CALIFORNIA COASTAL COMMISSION

**W10c****ADDENDUM**

SUBJECT: ADDENDUM TO **ITEM W10c**, COASTAL COMMISSION PERMIT APPLICATION **#5-11-075(Kramer)** FOR THE COMMISSION MEETING OF **December 2011**.

Subject: 323 West Avenida Valencia, San Clemente, Ca. Application No. 5-11-075.

EXHIBIT # 10
PAGE 15 OF 19

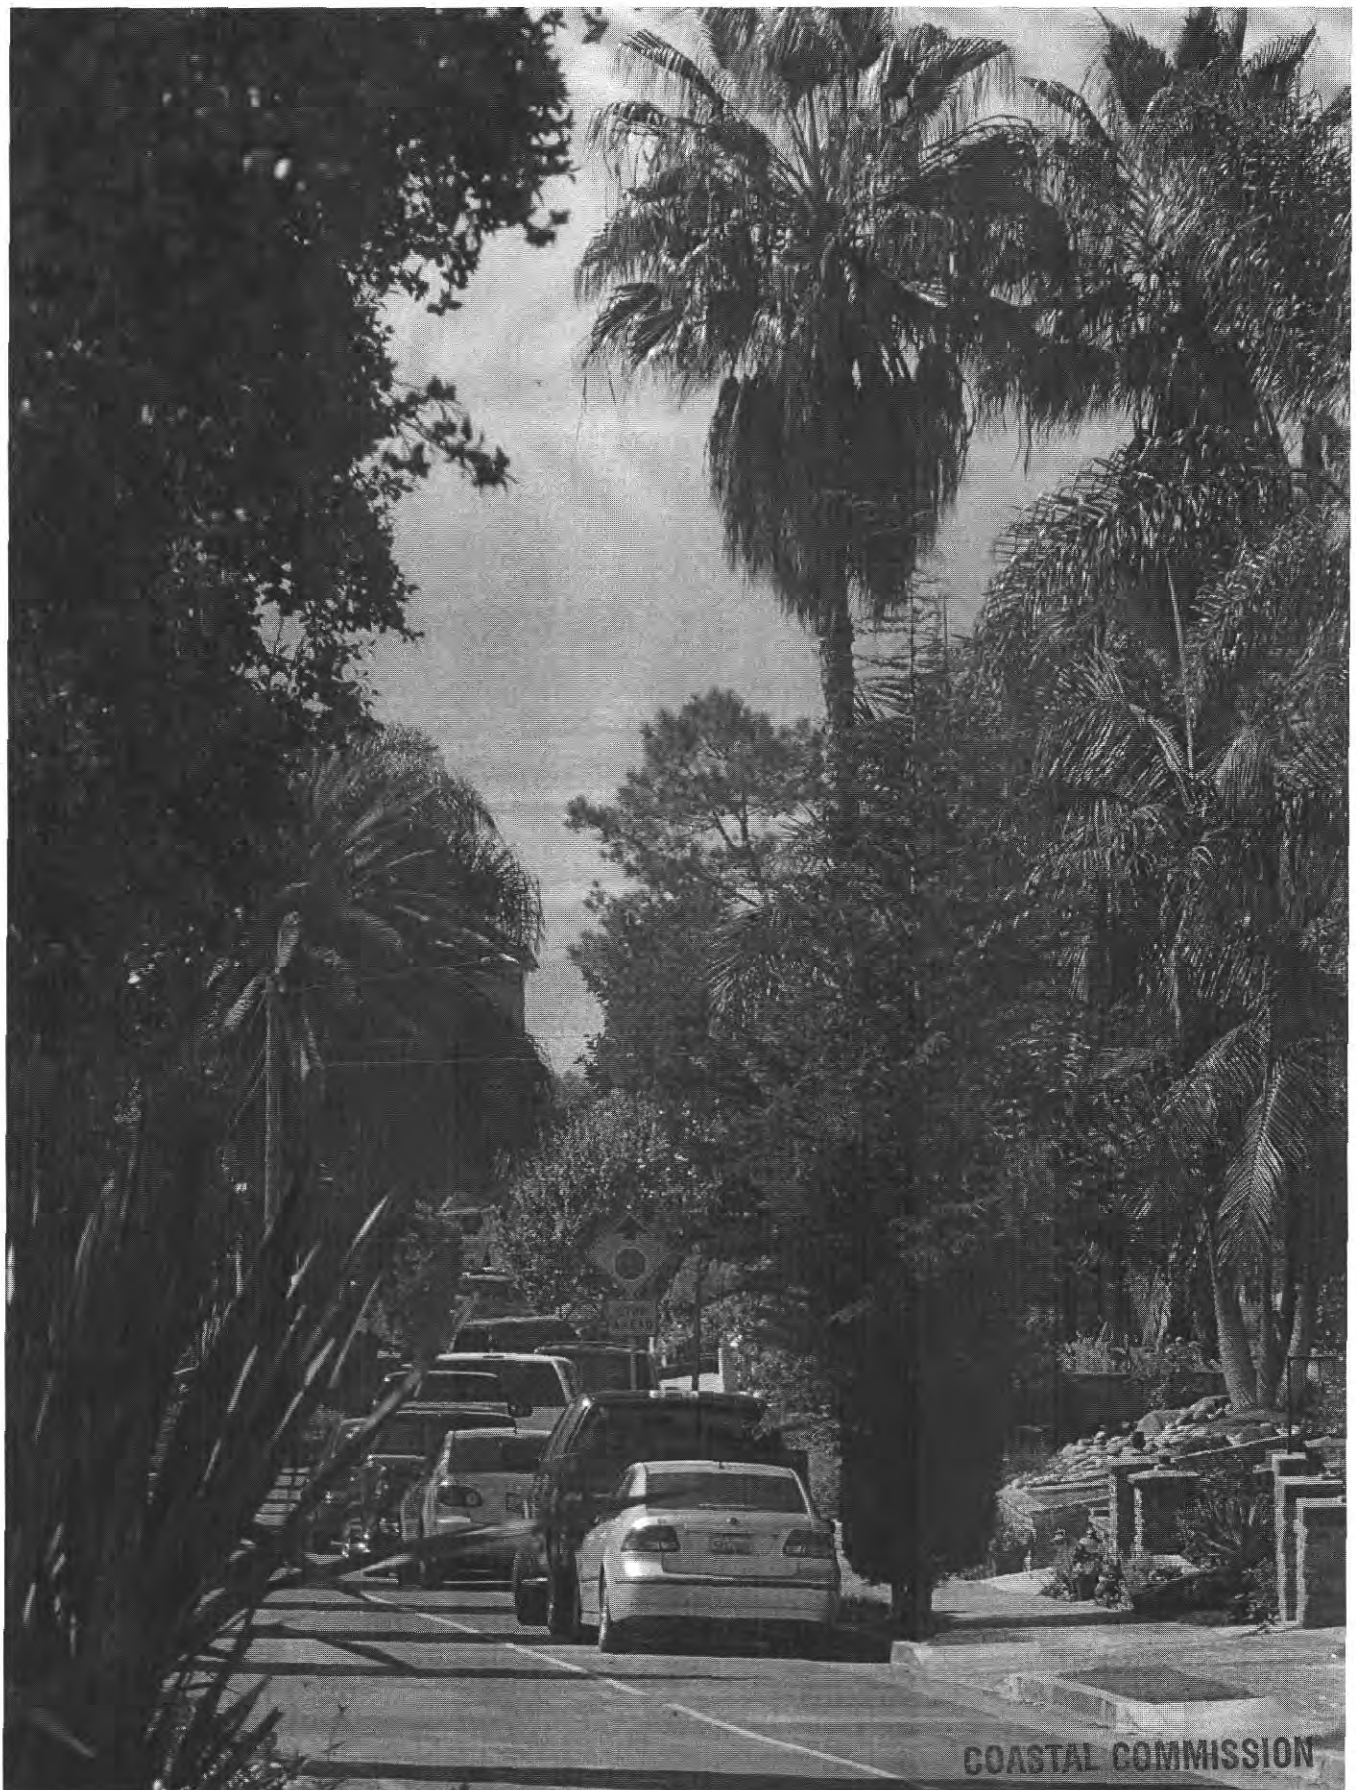
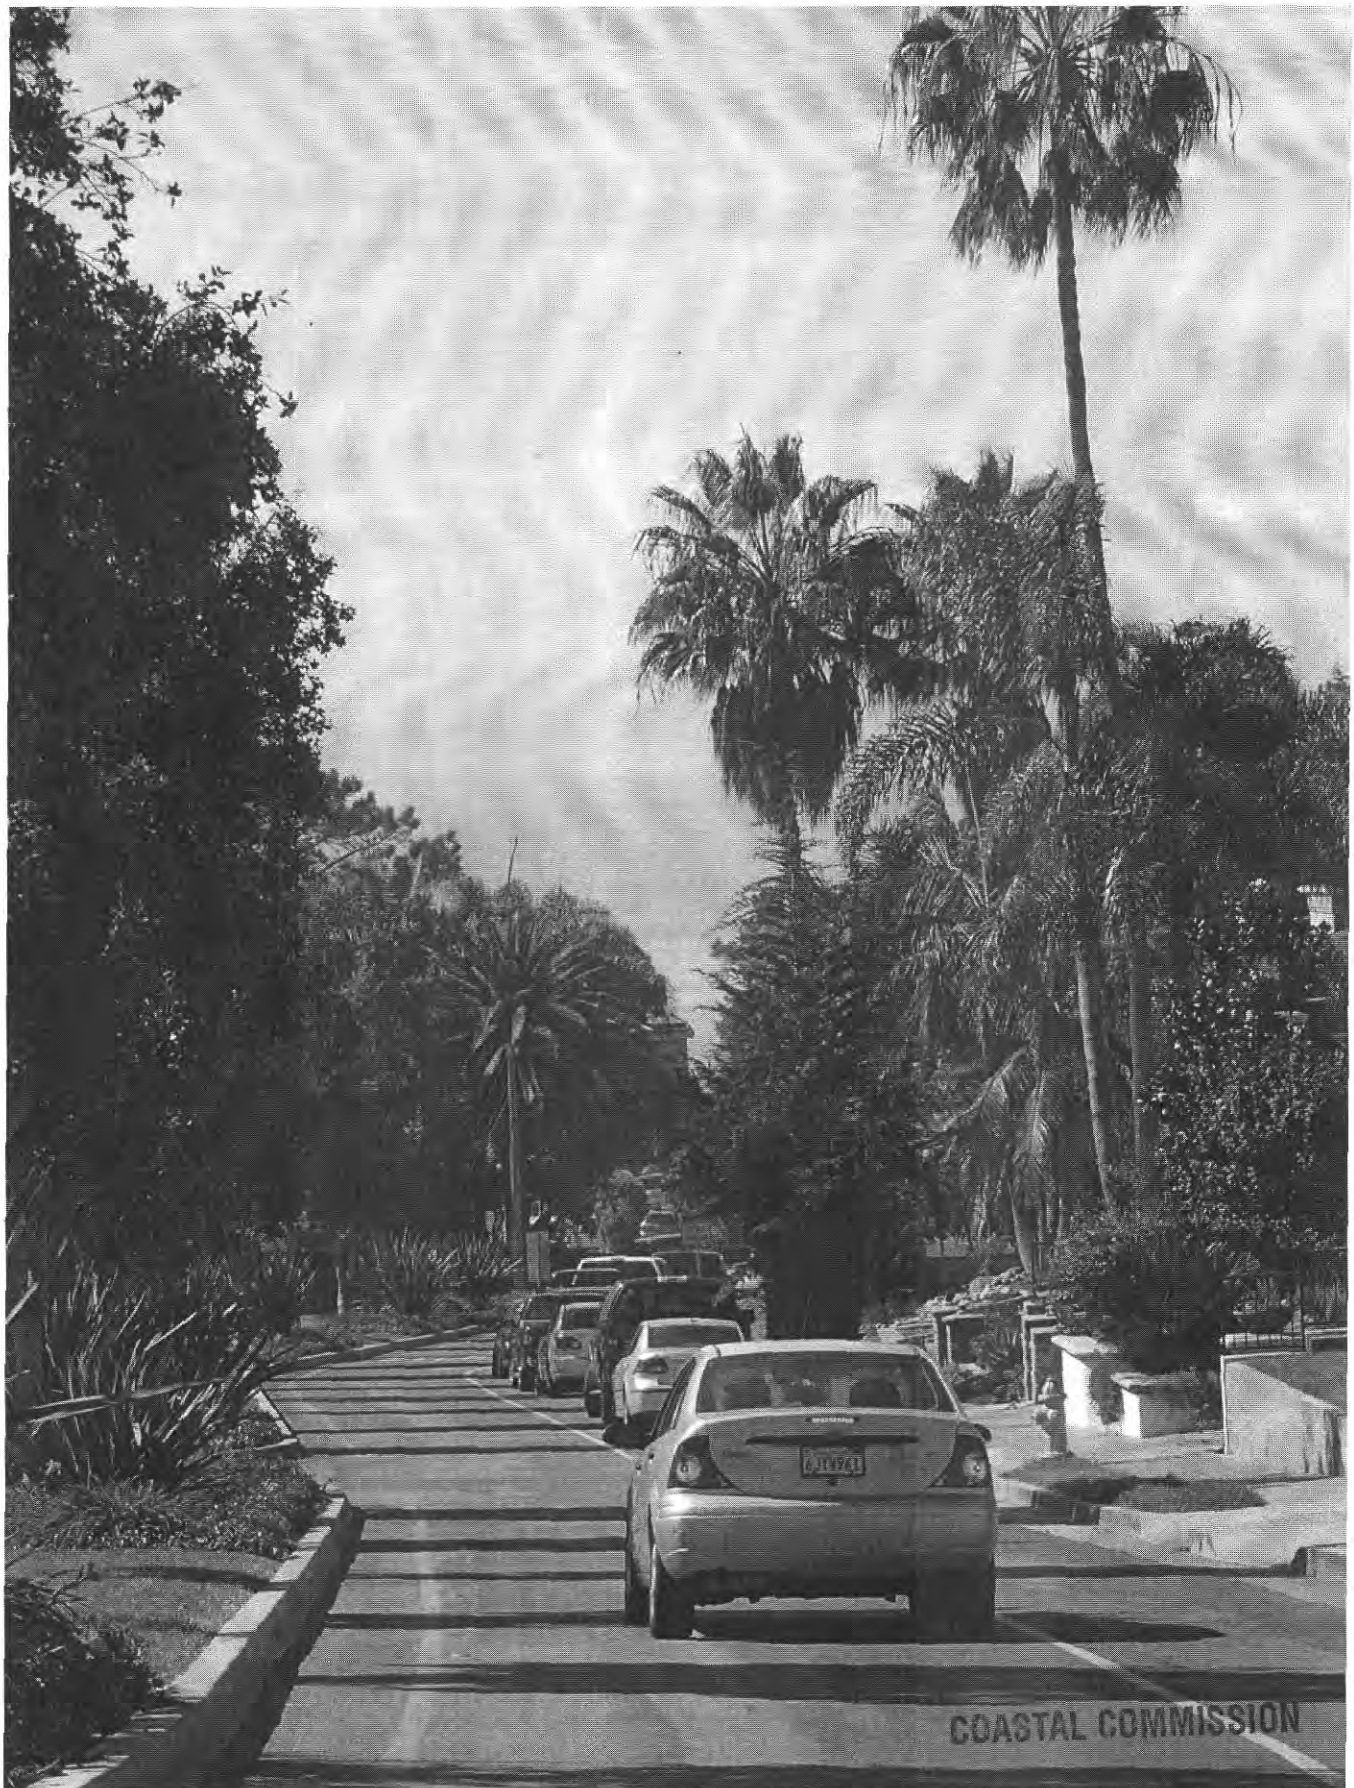
Local opponents to the project have argued that the project would interfere with existing view corridor. Photographs submitted show a distant narrow view corridor of the ocean between single-family residences and mature trees travelling southbound on Avenida Valencia. Other photographs show views from the public sidewalk in front of the existing residence that are partially obstructed by vegetation, deck railing and side yard fencing (Exhibit #10, pages 15 thru 19).
